Product Change Notification

113271 - 00

Change Notification #: 113271 - 00
Change Title: Intel® Server System P4308SC2MHGC
PCN 113271-00, Product Design
Update the Air Duct
Date of Publication: Oct 2, 2014

Figure 1: Post Change Air Duct Overall View

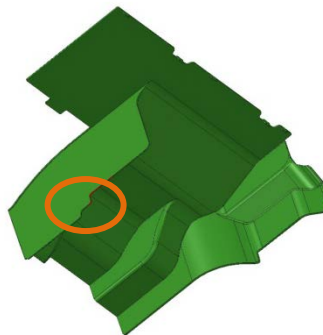
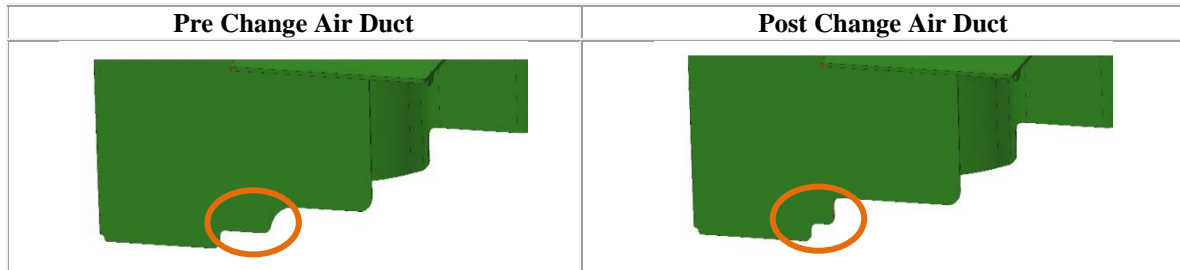
Update the outer edge of the air duct to make its installation easier.
